September 26, 2024

ADDENDUM NO. 1
to
THE CONTRACT DOCUMENTS, SPECIFICATIONS AND PLANS
for
LIBRARY ELEVATOR UPGRADES
PROJECT NO.: PW 24-03

SECTION 142400 - HYDRAULIC ELEVATORS

FIRST FLOOR NEW WORK PLAN

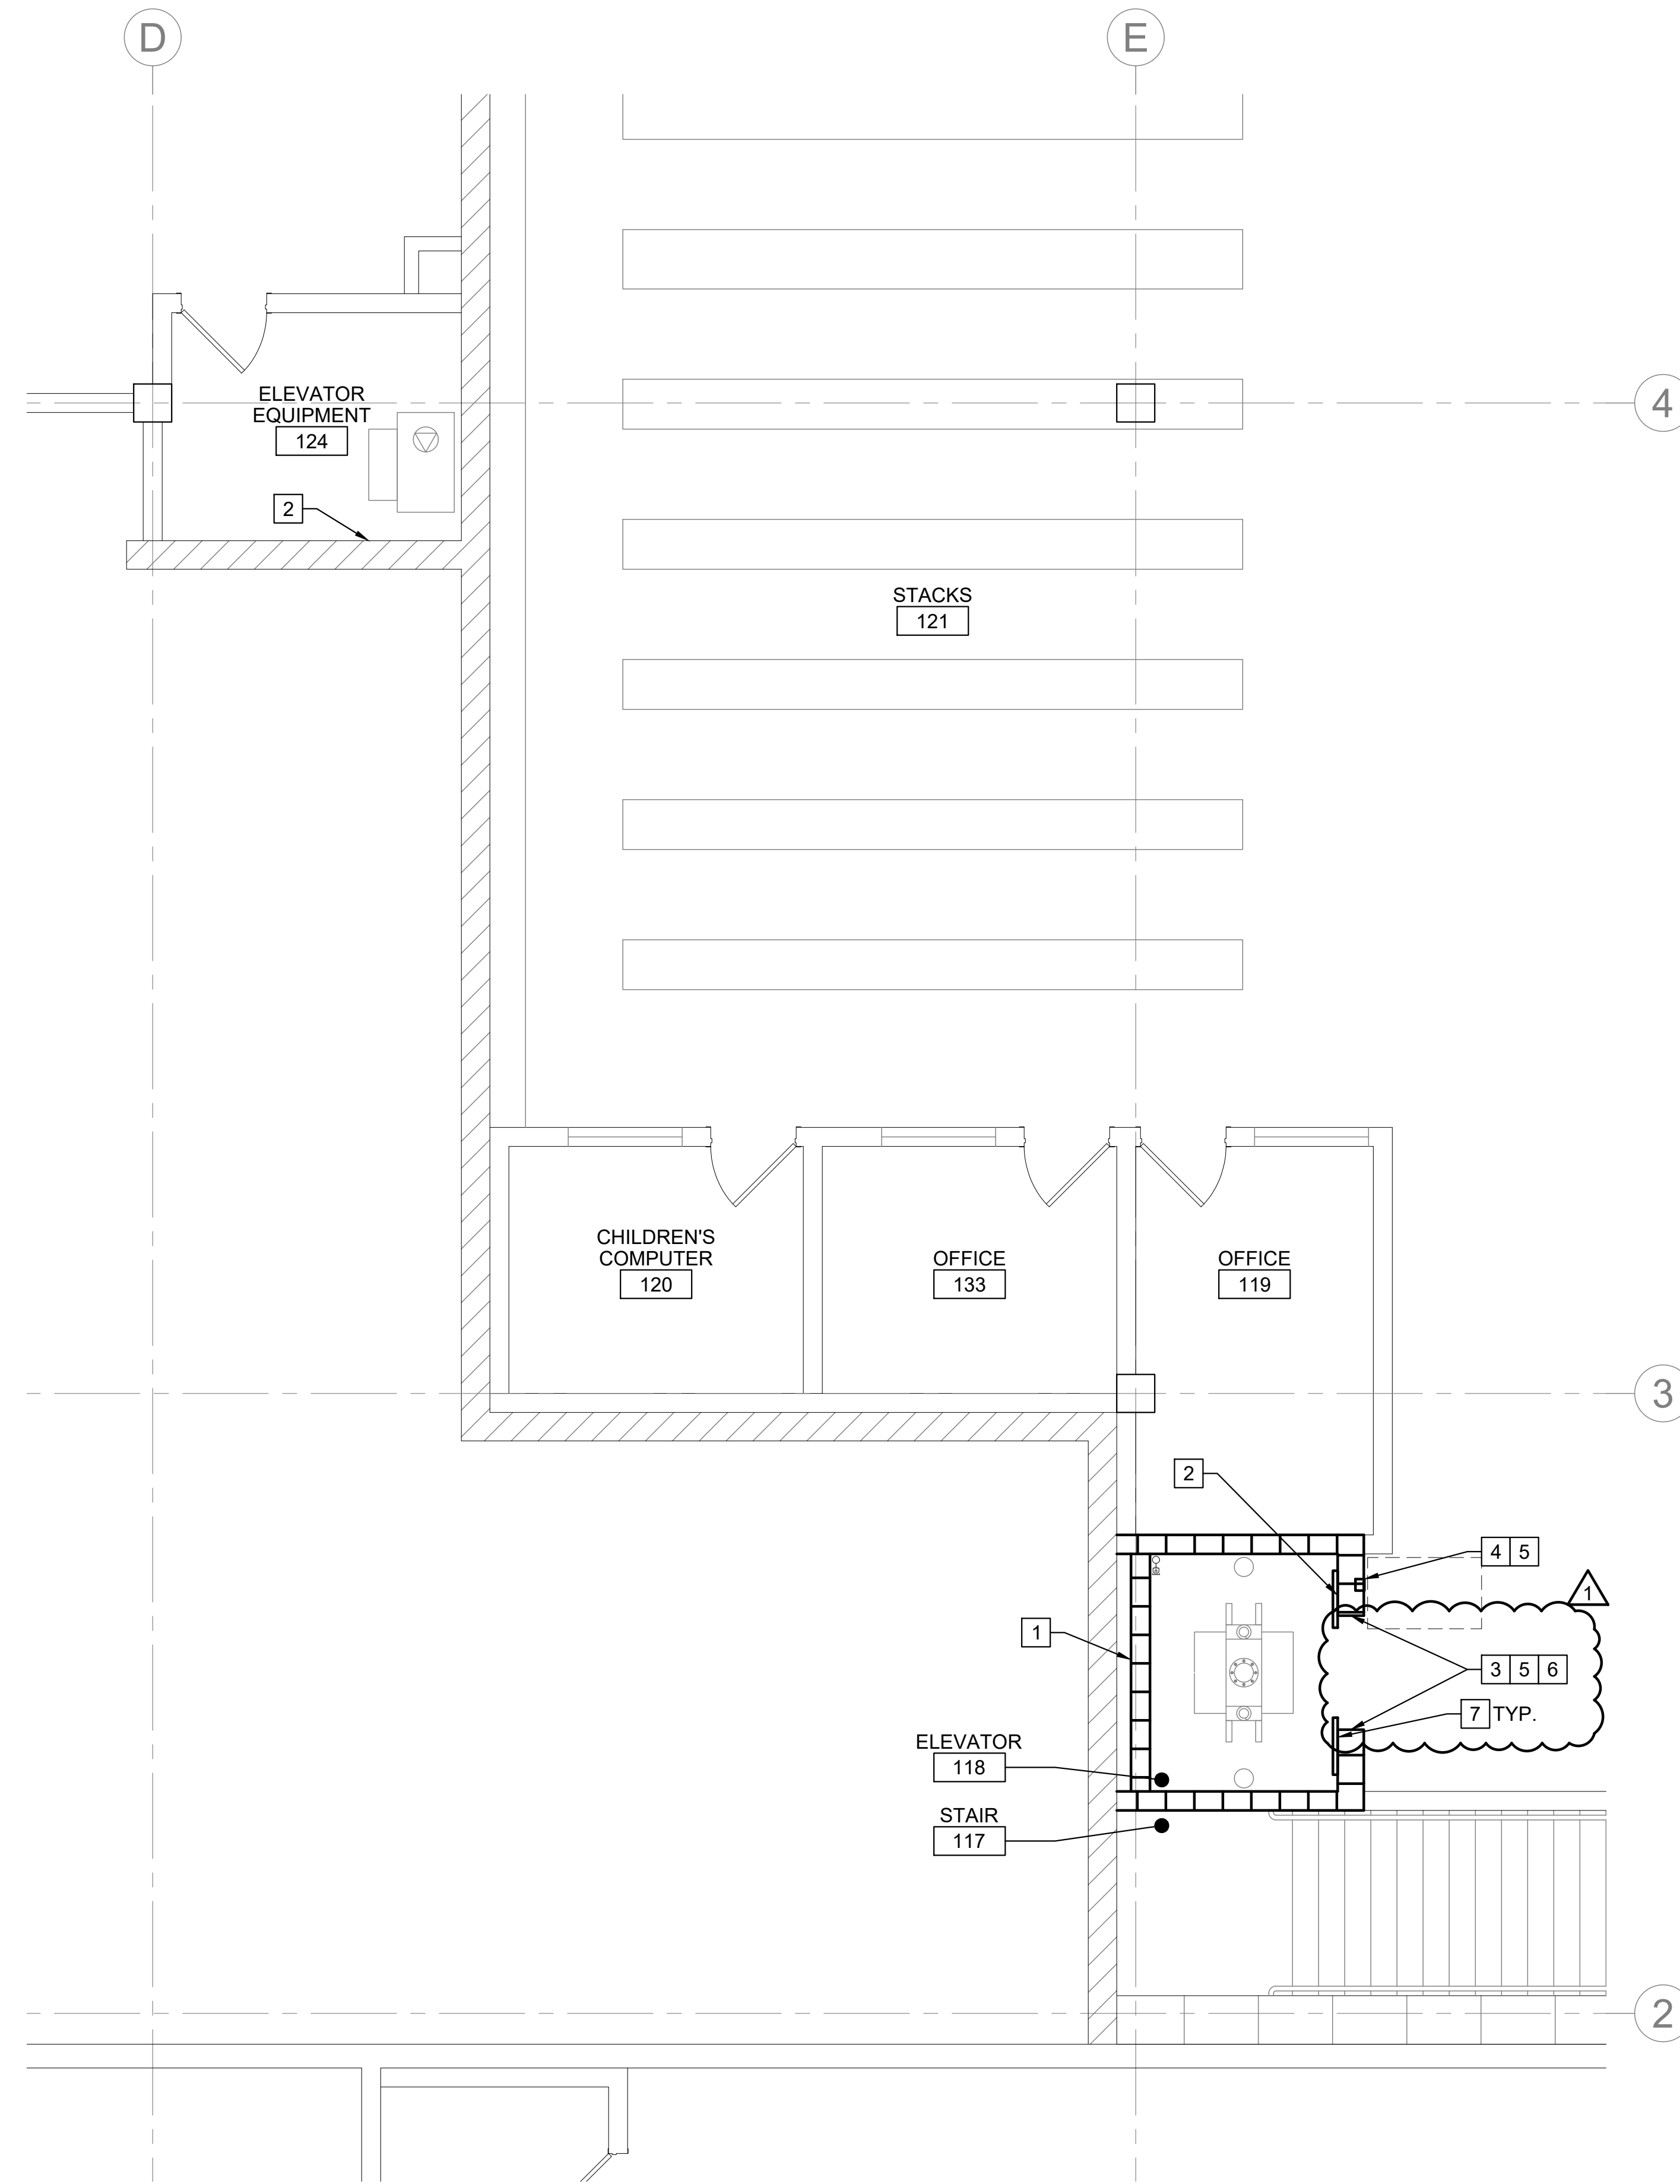
Question 2: Are we re-cladding the existing openings/jambs. Total of (2) To a SS #4?

Question 3: What is the desire of the City to do with the gold finish inside of the elevator cab? (IE Transoms, headers, returns) Keep handrails? Or replace handrails with SS #4 round? Replace the walls with SS #4 panels? What specifically does the city want with the ceiling? What specifically does the City want for the flooring? Do we retain the gold car sills? Do we retain gold hall sills?

Question 4: The specs calls for the replacing the existing Door Operator and Motor. Do we retain hall and car door track? Do we replace Hall and car door hangers and rollers? Do we replace hall door pick up assemblies? Do we replace Hall Door locks? Do we replace new door clutch? Do we install a new detector safety edge?

Question 7: With replacing cab interior doors with stainless steel doors and replacing cab interior with stainless steel interior it would be recommended to replace hall door panels with stainless steel and reskin/clad the entrance frames. As mentioned on job walk, is there a desire for a cab allowance rather than cab interior designs prior to bid due date?

- 1 REPAIR ELEVATOR SHAFT ENCLOSURE TO MEET 1-HOUR FIRE RESISTANT REQUIREMENT CBC 713.4.
- 2 PATCH ALL PENETRATIONS TO BE FIRE RATED. SEE MECHANICAL AND ELECTRICAL.
- 3 PROVIDE AND INSTALL (N) FLOOR DESIGNATORS AUDIBLE SIGNAL & HALL SIGNAL.
- 4 PROVIDE AND INSTALL (N) CALL BUTTON WITH RECALL 42" TO THE CENTER FROM FINISHED FLOOR. PROVIDE CLEAR FLOOR SPACE AT CALL BUTTON.
- 5 PAINT TO MATCH ADJACENT FINISH.
- 6 PROVIDE AND INSTALL (N) STAINLESS STEEL ELEVATOR SHAFT JAMB.
- 7 PROVIDE AND INSTALL (N) STAINLESS STEEL HALL DOOR PANELS, TRACK, HANGER, PICK UP ASSEMBLY, LOCKS, AND INFRARED SAFETY EDGE.

Answer: Yes, see revised plans.

Answer: All interior finishes to be replaced, including handrails, transoms, etc. See revised plans.

Answer: Elevator Door and track assembles shall be replaced. See revised plans.

Answer: Yes, replace hall door panels. See revised plans.

1 ELEVATOR SECTION
M4.1 SCALE: 0 1 2 3 FEET 4
 1/2" = 1'-0"

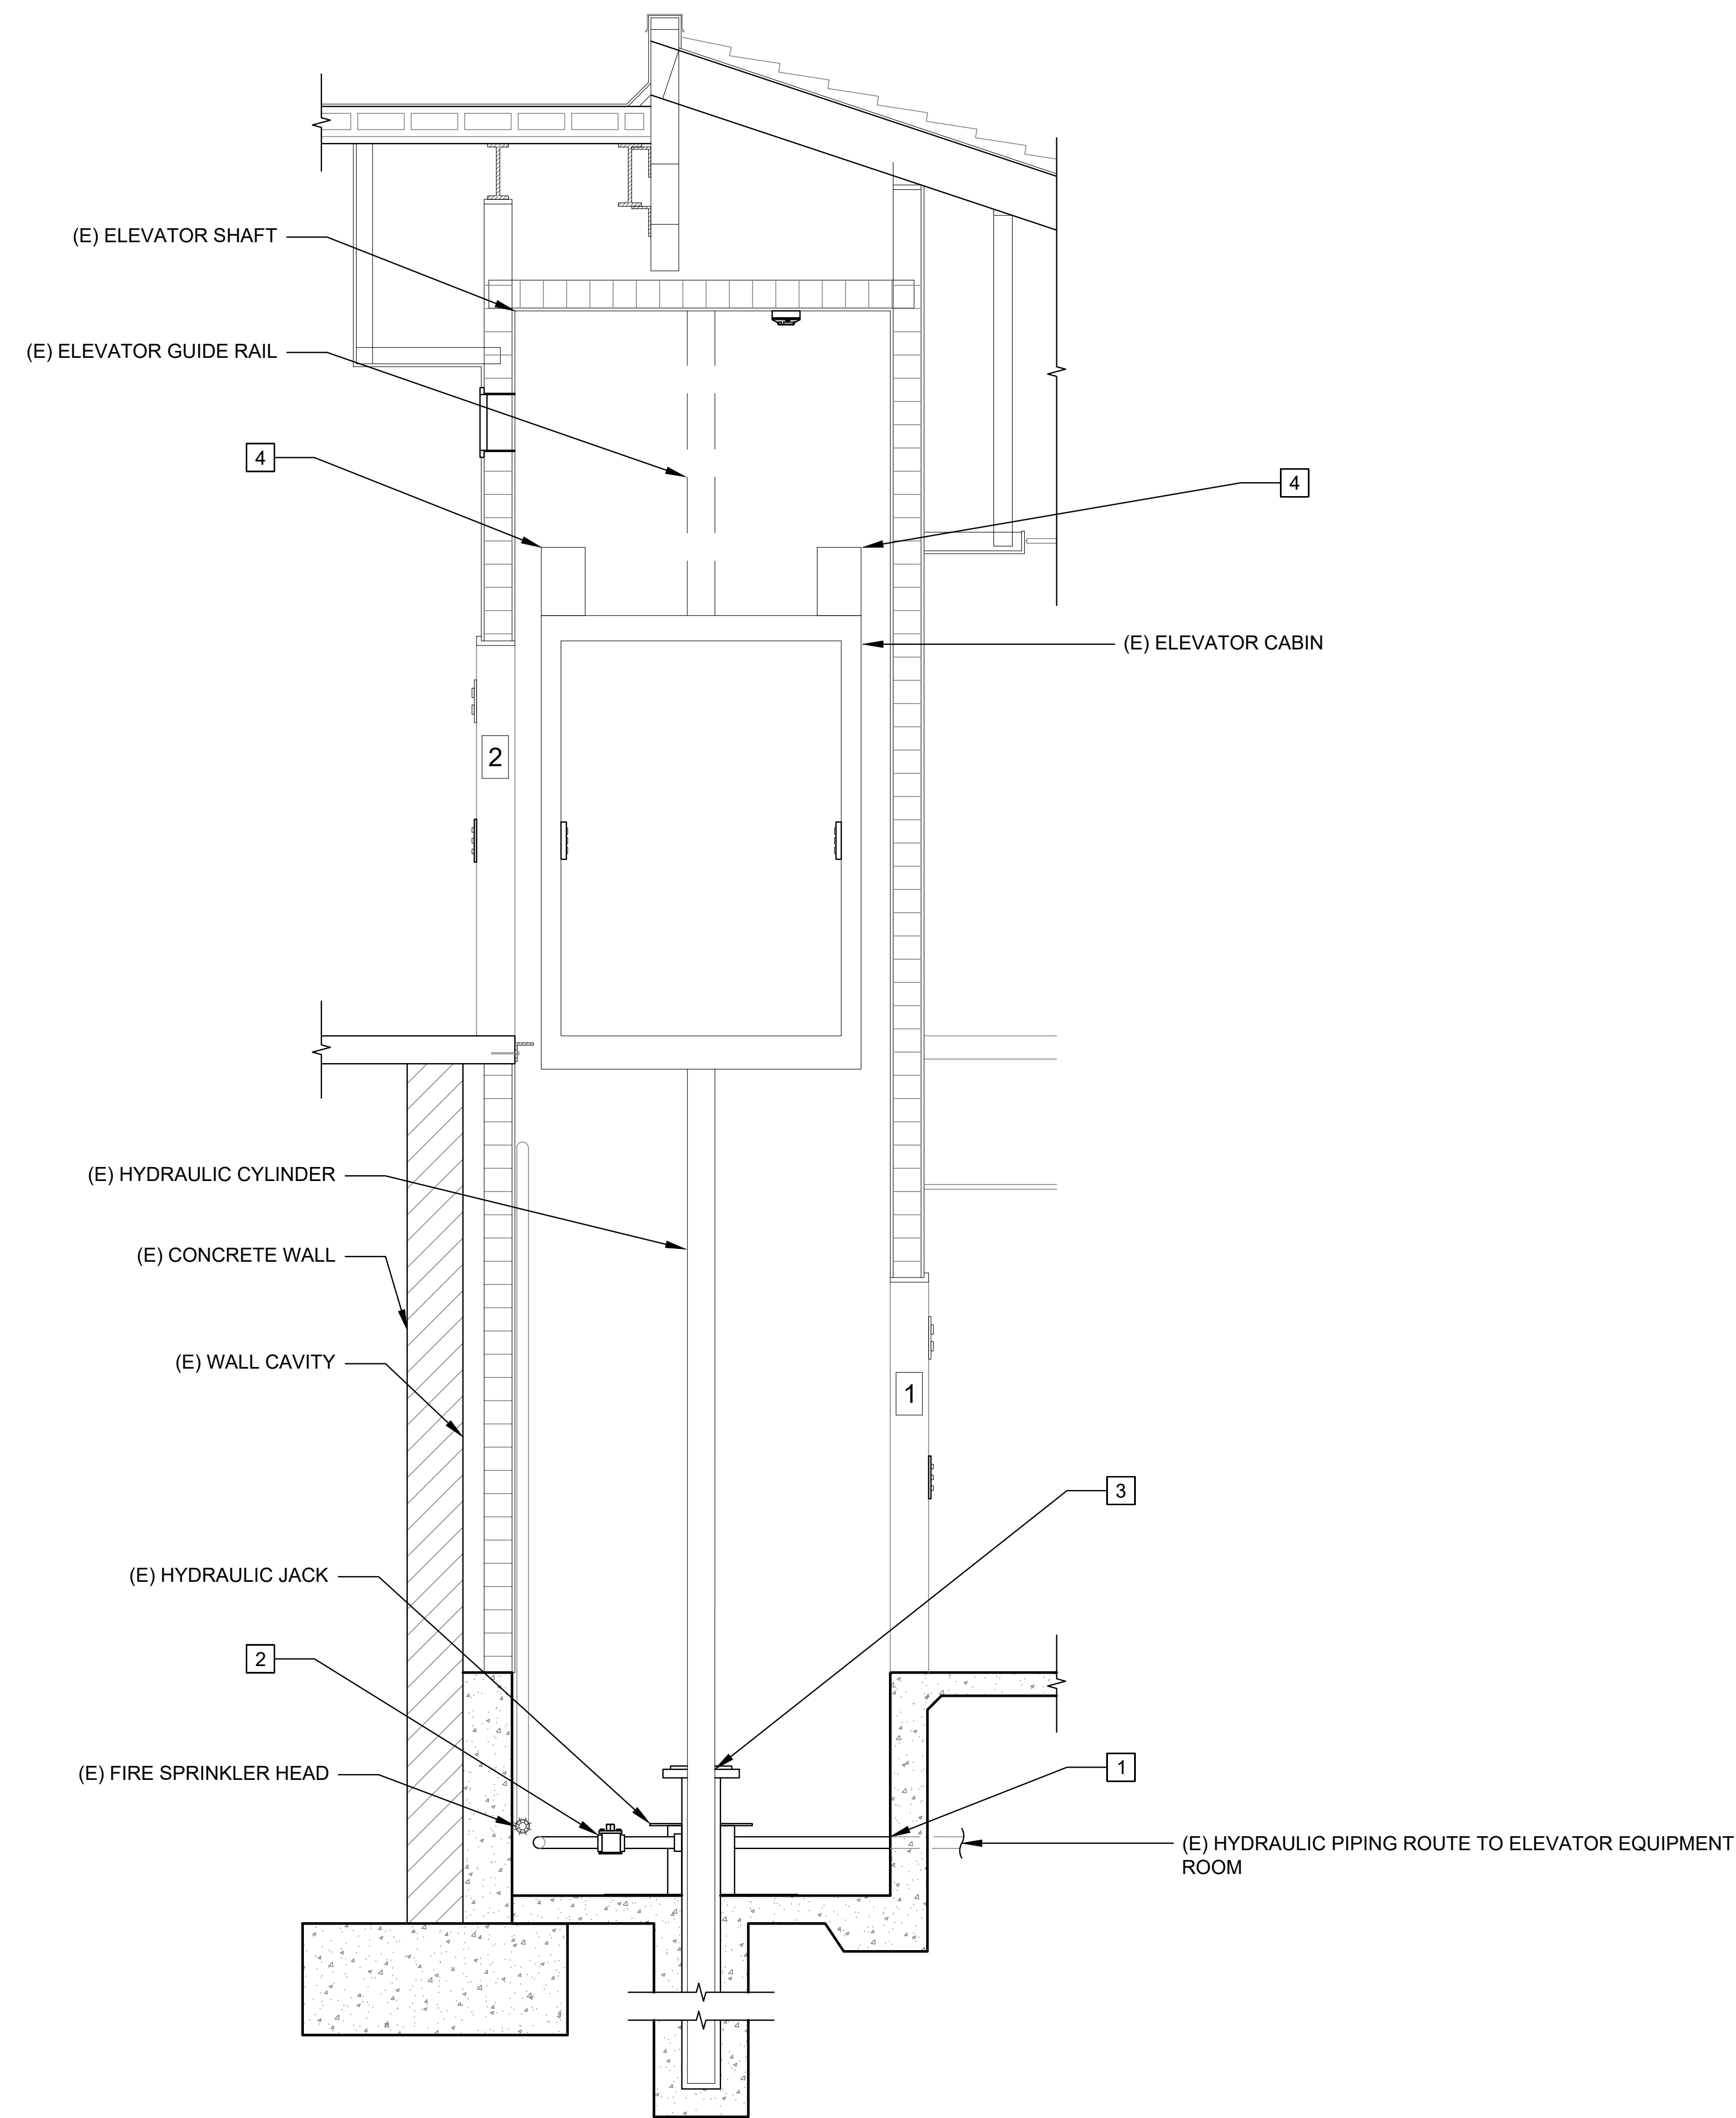
Question 5: In the elevator pit. You asked to replace the pit piping to last Victaulic before going to wall. Please confirm. Do you want to install a new rupture valve? Do you want to install a ball valve?

- 1 PROVIDE AND INSTALL (N) HYDRAULIC FLUID PIPING.
- 2 PROVIDE AND INSTALL (N) RUPTURE VALVE.
- 3 PROVIDE AND INSTALL (N) HYDRAULIC CYLINDER PACKING.
- 4 PROVIDE AND INSTALL (N) ELEVATOR DOOR OPERATOR AND CAR TOP BOX

Answer: Yes, new rupture valve. See revised plans.
